**ADDENDUM NO. 1 – JOB SA5741**

**ARKANSAS DEPARTMENT OF TRANSPORTATION**

# JOB SA5741

**HWY. 8 - SOUTH (OVERLAY) (S)  
CO. RDS. 56 & 57  
POLK COUNTY**

**SHEET 1 OF 10**

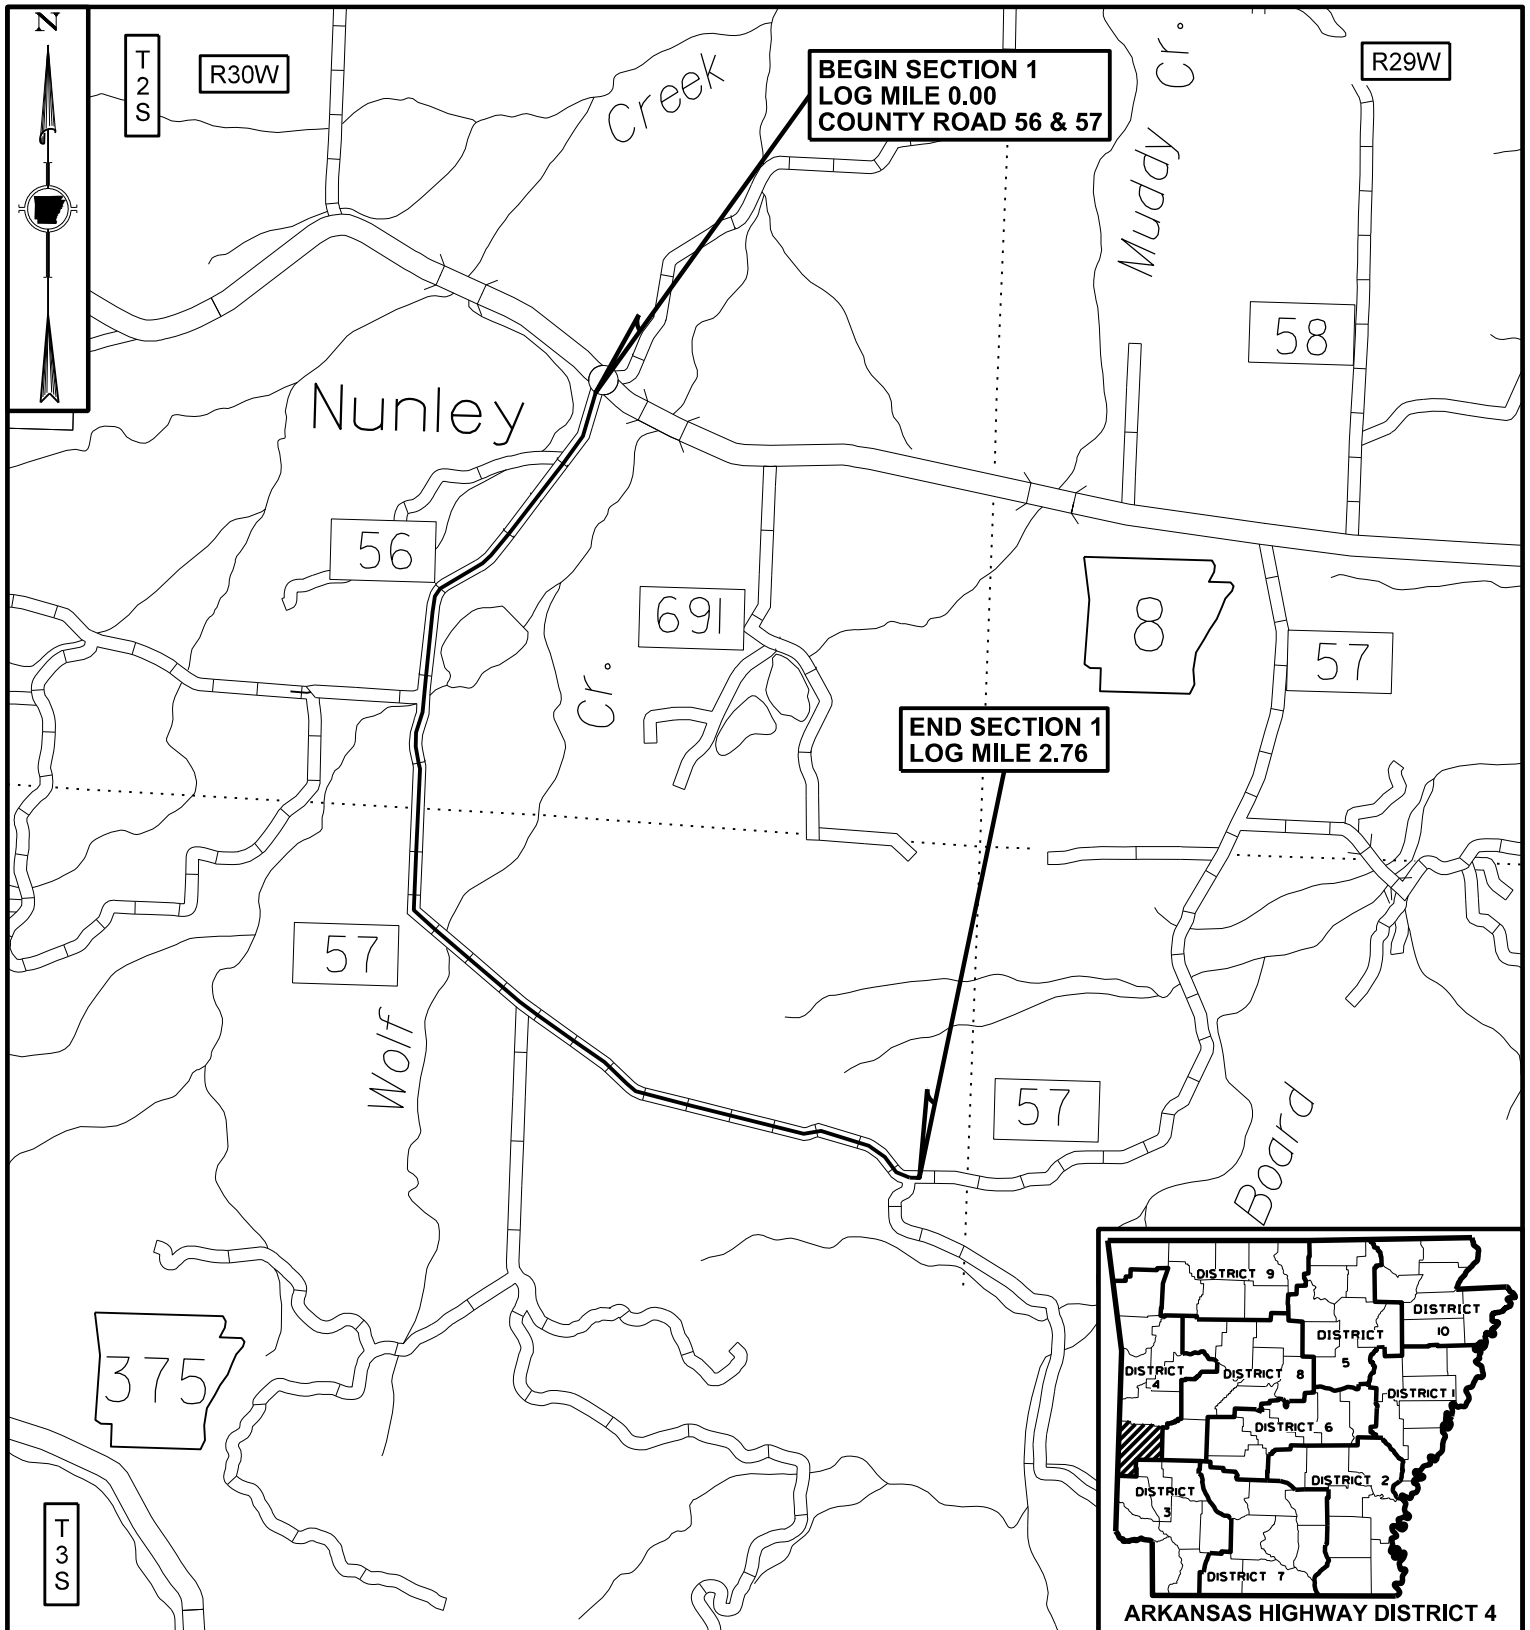
The project length has been reduced by 0.41 mile. The associated pay items have been revised as shown in the table below. Lettersize Plan Sheets 1, 6, 8, and 10, Proposal Document Page 2, the Proposal Schedule of Items (1 page), and the EBS file have been revised to reflect these changes. You should substitute the revised sheets into your proposal documents and consider these revisions when submitting your bid.

REVISED 03-14-24

## SUMMARY OF QUANTITIES

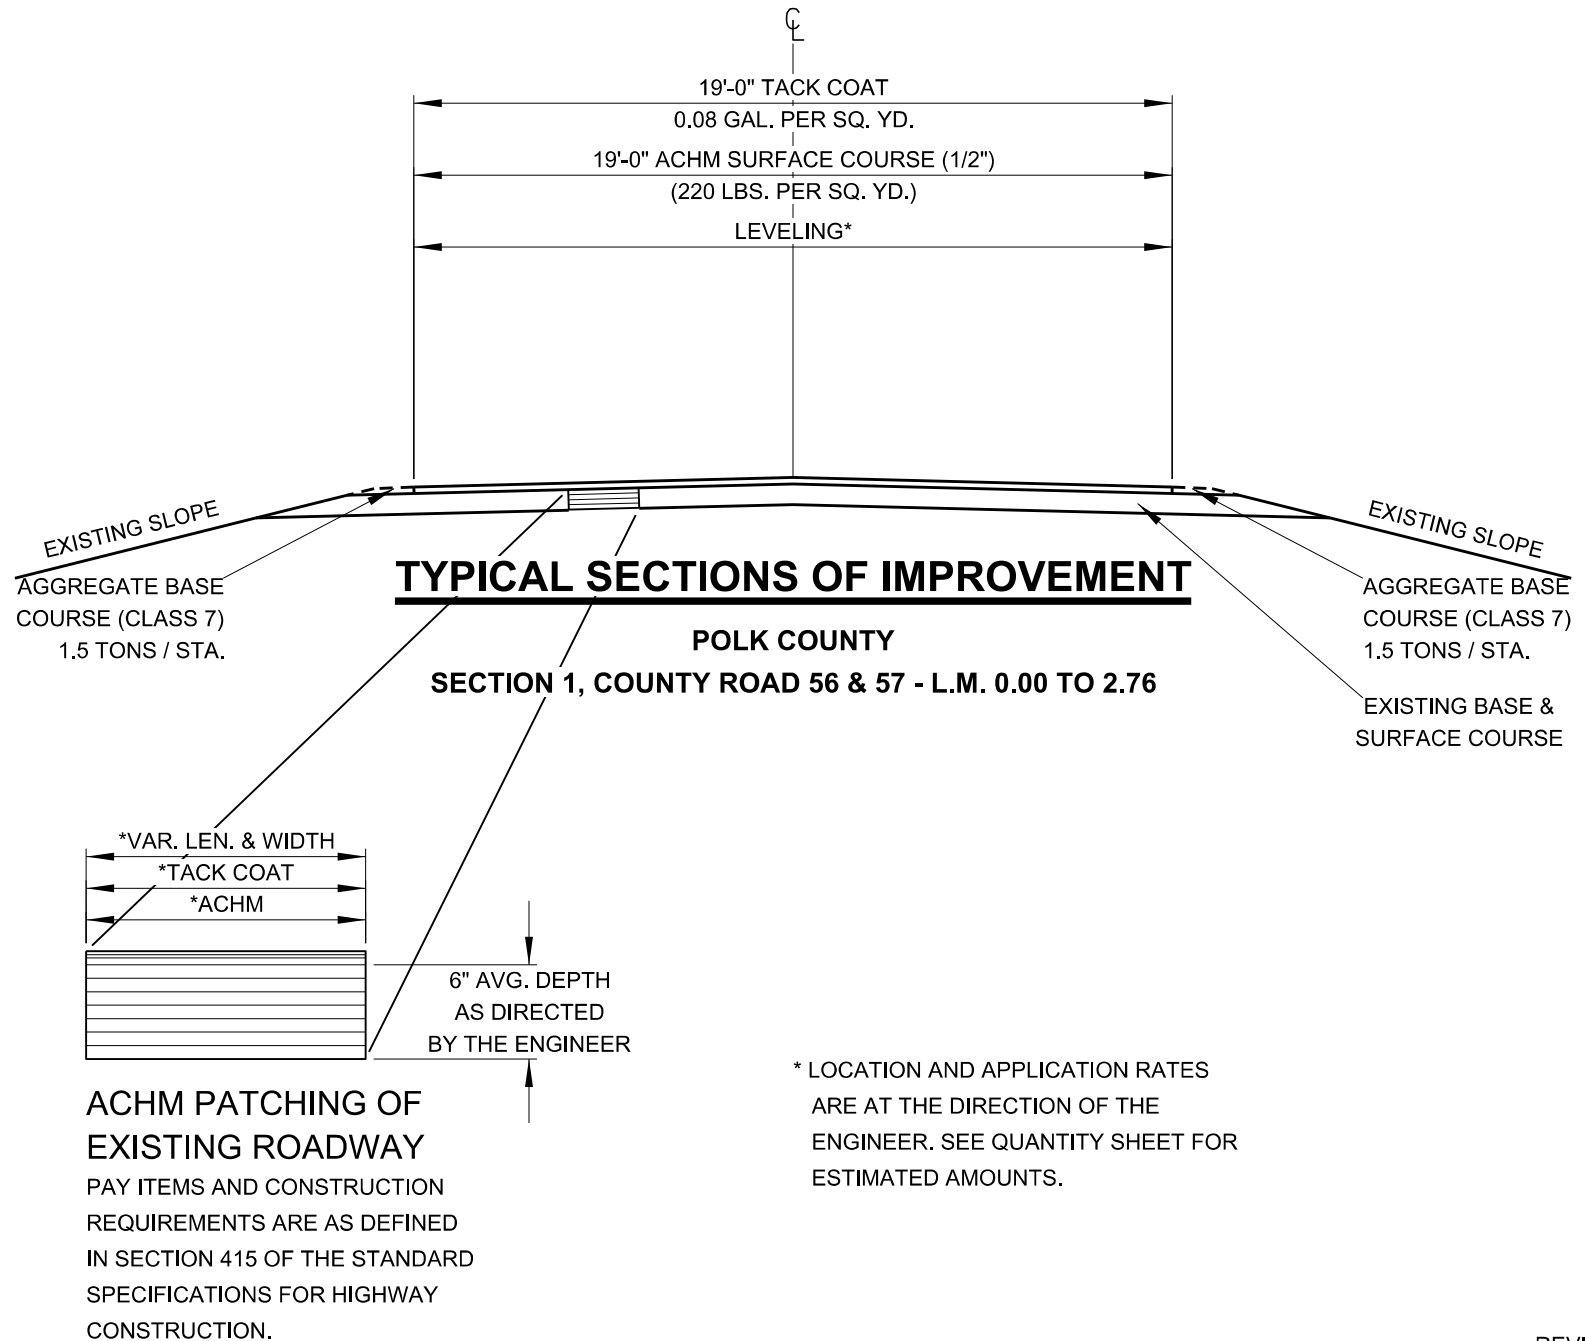
DATE	REVISION	SHEET NO.
3/14/2024	REVISED LENGTH OF SECTION 1 TO 2.76 MILES.	1, 6, 8, & 10
